Proposed Revisions to a Standard Plans Index

Index Number: 700-090

Index Title: Dynamic Message Sign Walk-In

SHEET
1 of 5

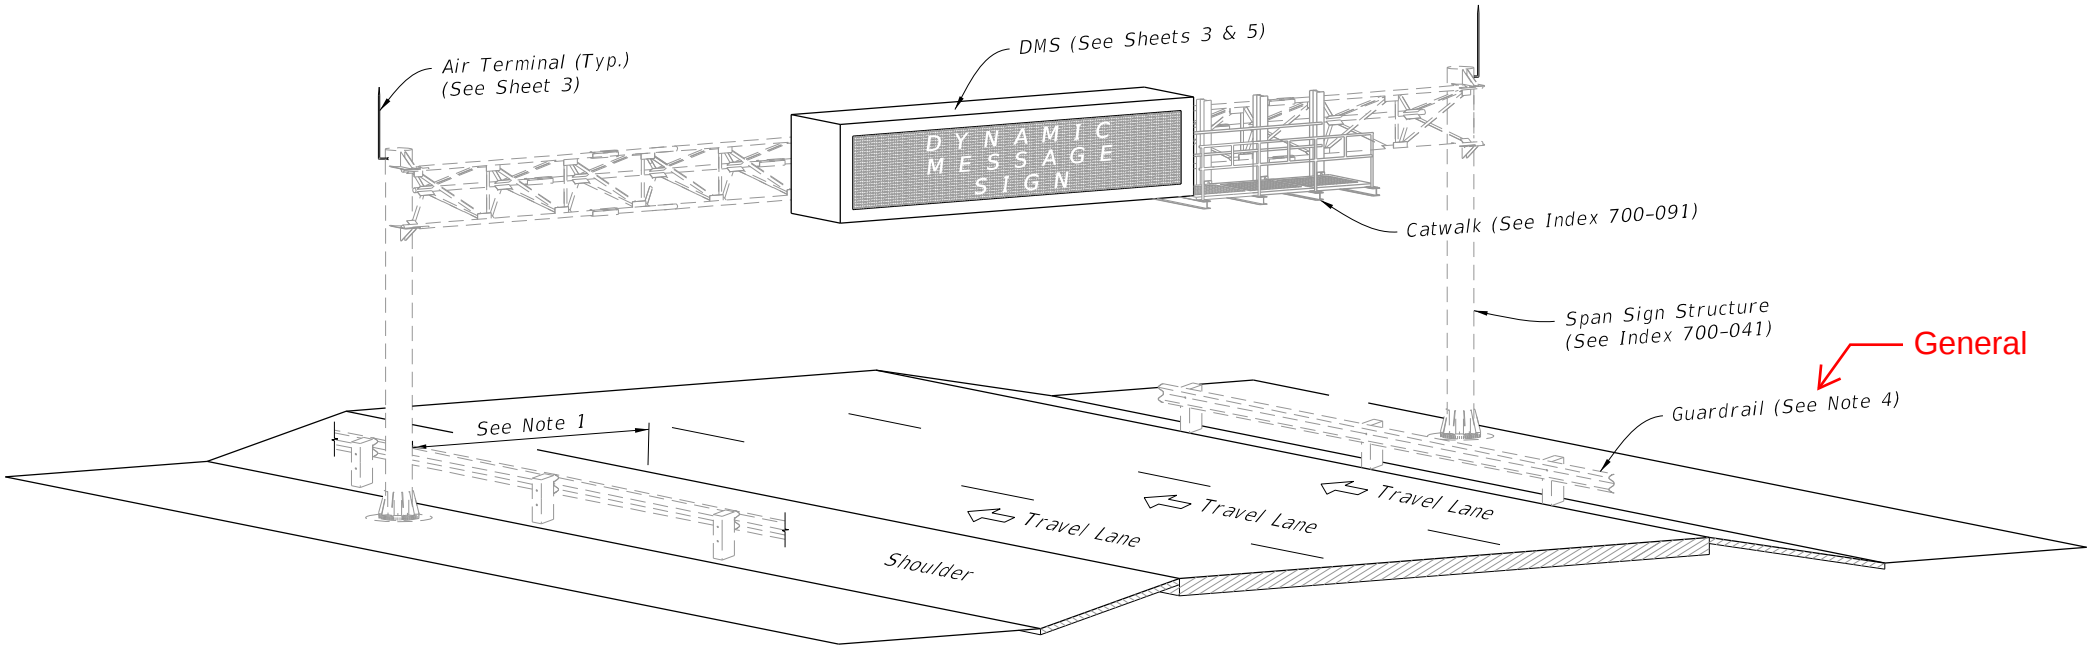
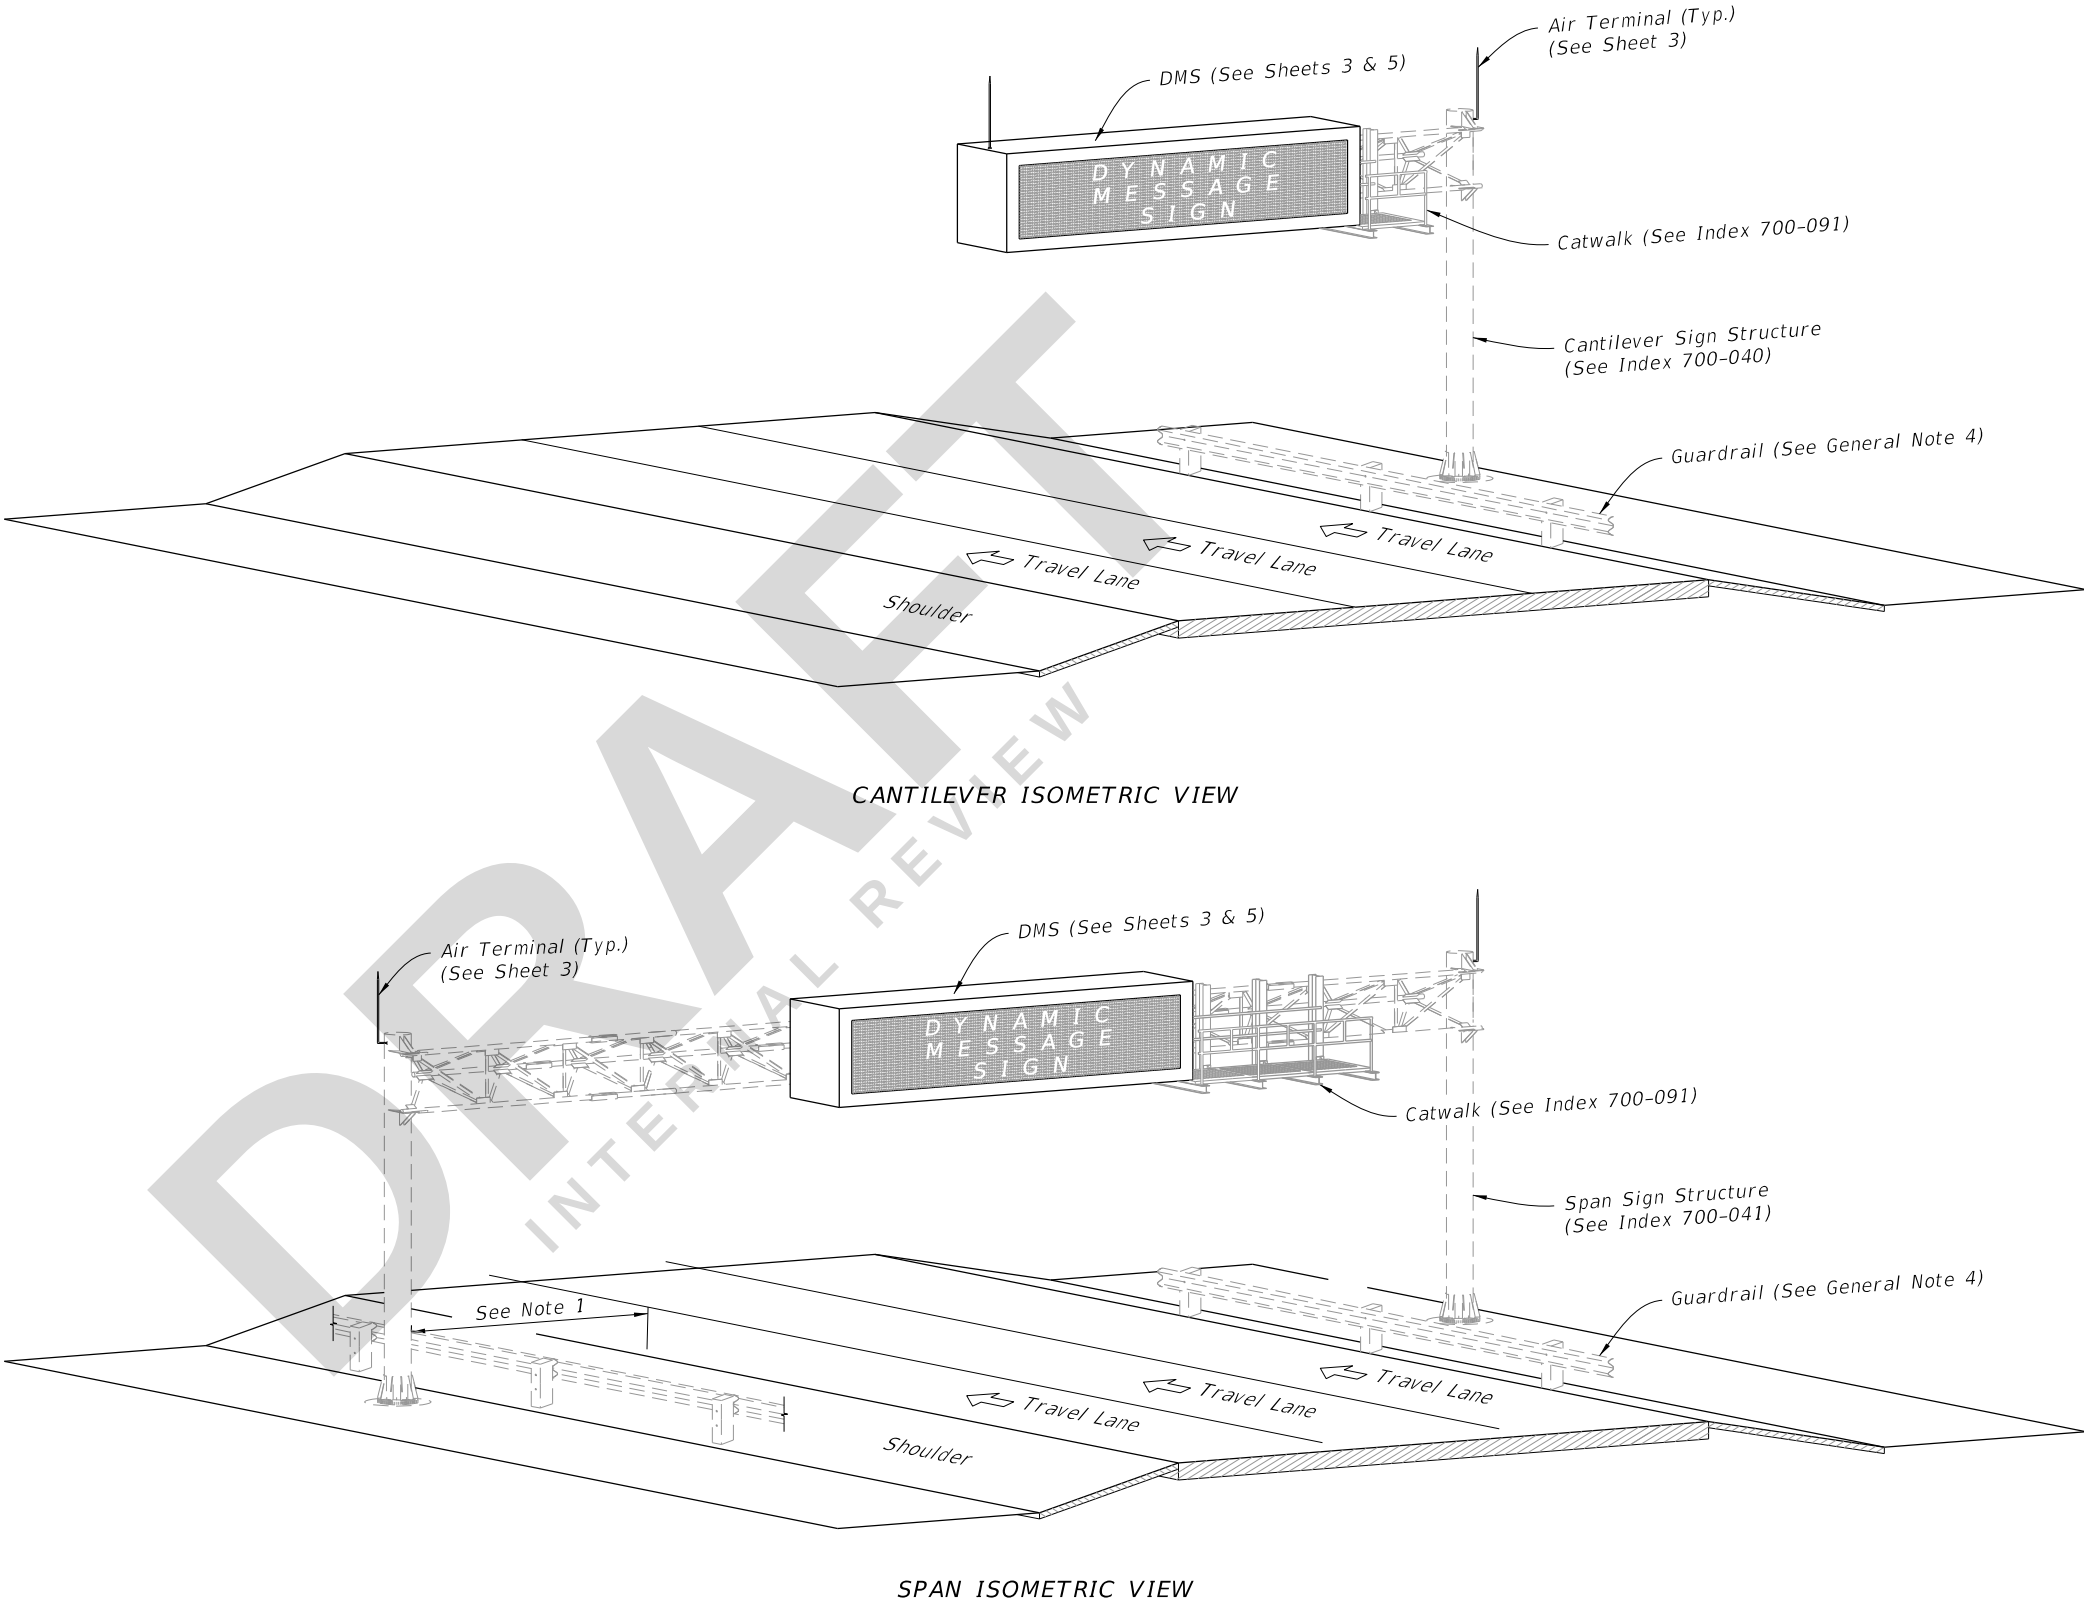
Updated General Note 1 - "Meet the requirements of Specification 700."; Deleted Note 5; Renumbered General Notes.

1. ~~Work this Index with Specification 700.~~
2. Furnish and install the Dynamic Message Sign (DMS), sign structure in accordance with Index 700-040 or 700-041. Locate foundations at locations shown in the Plans.

DELETED

UPDATED NOTE: Meet the requirements of Specification 700.

GENERAL COMMENT: Material information was deleted. Information is either already covered in Standard Specifications OR will be added to Section 700, 962 or 965 in conjunction with these revisions.

1. Meet the requirements of Specification 700.
2. Furnish and install the Dynamic Message Sign (DMS), sign structure in accordance with Index 700-040 or 700-041. Locate foundations at locations shown in the Plans.
